File No: SP 23-04 Center Market

Proposal: The application is for a Site Development Review for the redevelopment (demolish and rebuild) of the existing Center Market convenience store. The new structure is proposed to be 5,225 square feet, 3,780 square feet will be the new convenience store, 1,178 square feet is designated for a future retail/commercial tenant that is not identified at this time. The project also includes new pavement, parking areas, a basin, a plaza, new landscaping, a kitchen for the preparation of hot meal items, and the relocation of the driveway on NE Old Salem Road. The project would require the removal of several mature trees. The applicant is proposing the development of the site in three phases:

CIVIL SITE PLAN

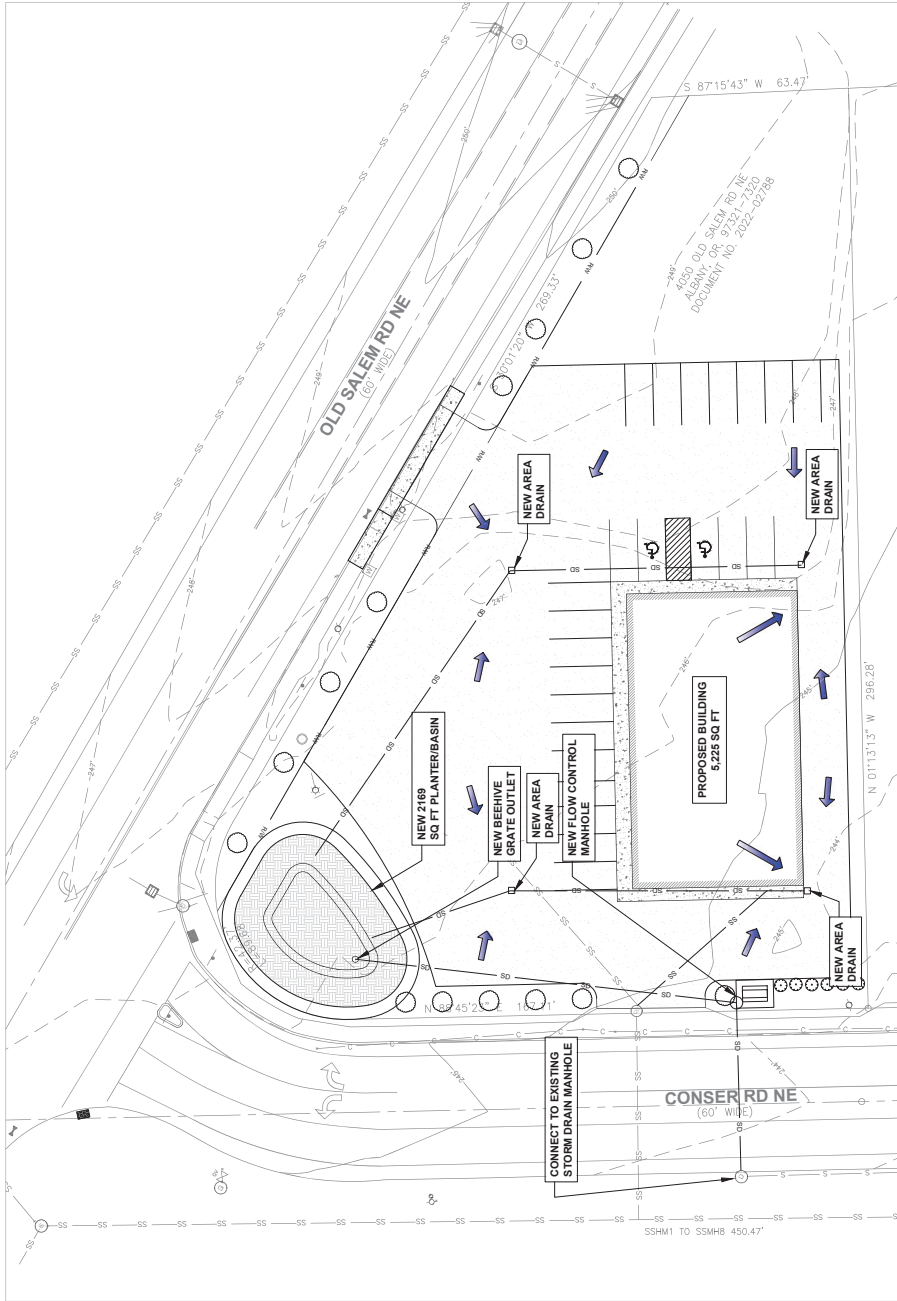
Staff has determined that the removal of the trees is a negative impact. While the Municipal Code may not require a tree removal permit, the intent of the Code is clear – trees of this size are something that should be considered significant. Having that said, it is necessary to consider the applicant's rights to develop his private property and the tree's locations do significantly impact the ability to use the site (see the applicant's narrative regarding trees and their root zones).

Given the circumstances, staff has tried to address the issue in a way that is fair and reasonable. Staff recommend permitting the removal of the trees through this Land Use action. Staff worked with the applicant to arrive at a fair mitigation which will require a 2-to-1 tree replacement for the six Oak Trees removed. A condition of approval has been included, see below. The condition will require 12 additional trees

- Prior to the issuance of building permits, the applicant shall provide a revised site plan showing:
 - Internal vehicular and/or pedestrian connection locations with the neighboring lots. These need not be constructed at this time, but must be shown on the plans.

- Curbed, 5 feet wide landscape planters shall be included at the ends of each series of parking spaces.
 - Clear vision areas shall be shown in compliance with Section 3.08.060 of the Development Code.

ANALYSIS: Planter bays are required. A planter bay essentially means that the ends of parking space areas must include a planter with curbs, a tree, and landscaping. The code says that a curbed, 5 feet wide planter is required at both ends of the parking spaces located in front of the building and the side of the building (total of 4). The plans do not include these planters. A condition of approval has been added to require the plans to be revised, and construction with irrigation of these planters.

- Prior to the issuance of building permits, the applicant shall provide a revised landscape plan showing the following revisions:
 - Curbed, 5 feet wide landscape planters shall be included at the ends of each series of parking spaces.
 - A tree and other required landscape plantings for each planter shall be shown on the plans.
 - All street trees shall be removed from all clear vision areas.
 - The location of all Oak Tree replacement mitigation trees.

DRAWING:
 Exterior Elevations

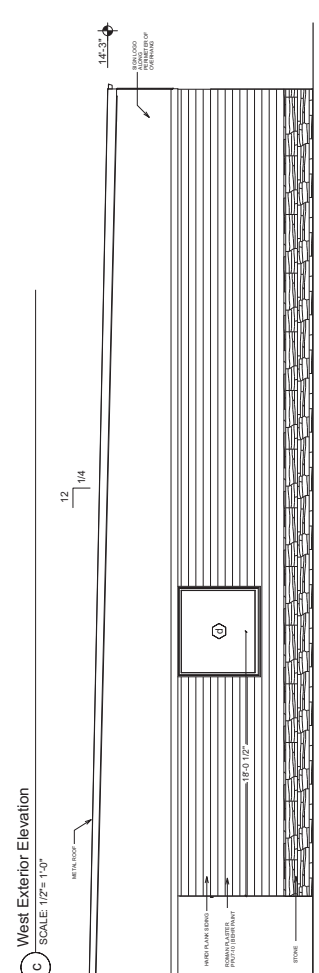
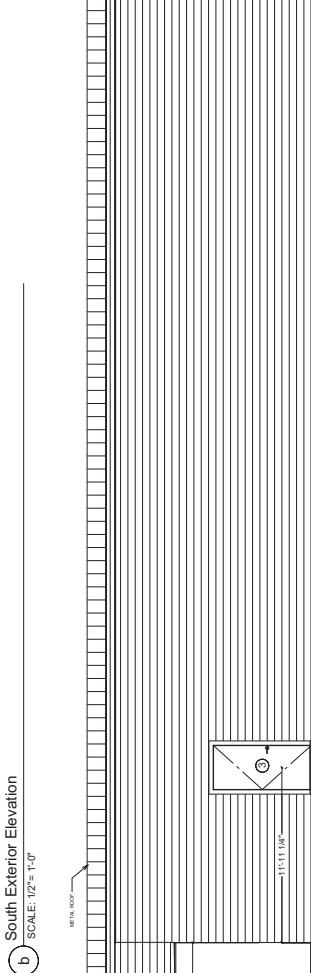
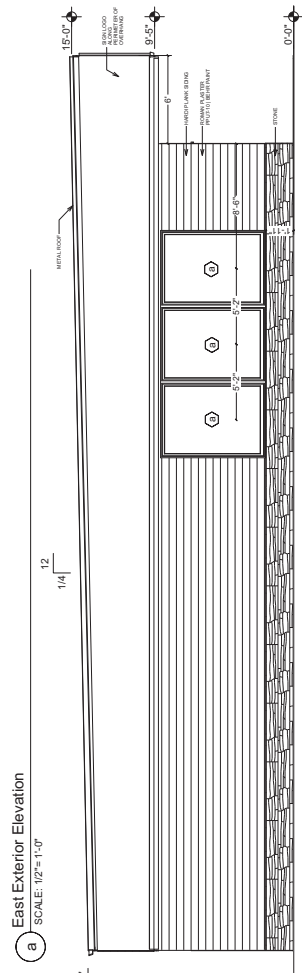
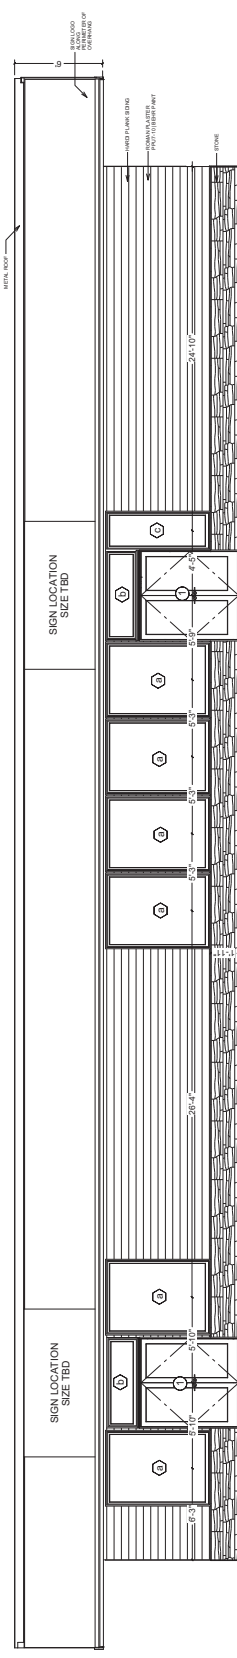
The exterior of the north, south and east facing wall include stone wainscotting and an overhanging awning. The rear wall of the structure, facing west, is highly visible from NE Conser Road and is also, therefore, required to comply with all design standards as well. As shown on sheet A3.0 view C, the rear does not include any architectural features and is therefore inconsistent with this requirement and must be revised. This is discussed below in more detail. With conditions of approval, this standard is met.

As discussed above, the rear wall of the building does not meet this requirement. All other walls do. The rear wall will be highly visible from NE Conser Road. The aesthetics of this wall are very important based on this high visibility. The strict application of this requirement is not practical because windows on the rear of the structure of a convenience store are not typically included. However, the intent of the provision is clear, the rear of the structure should include some kind of aesthetic feature. A condition of approval has been added that will require

the addition of architectural features intended to break up the massing of the structure and make the structure aesthetically pleasing from NE Conser Road. Because this is subjective, the Planning Commission can add any details to the condition in order to assure (to the Commission) that the requirement will be satisfied. The condition requires the applicant to work with Staff to satisfy the condition, this way the project does not have to come back to the Planning Commission. Staff found this to be a reasonable interpretation of this development standard, though, ultimately, it is up to the Planning Commission.

13. Prior to issuance of building permits the applicant shall revise the rear elevation (west facing) to break up the massing of the façade and include at least one (1) architectural feature intended to make the view of the rear wall from NE Conser Road aesthetically pleasing. This can include stone wainscoting, awnings, bump outs in the wall plane (at least 6 inches), to add shadows along the facade throughout the day, landscaping, or any other feature that
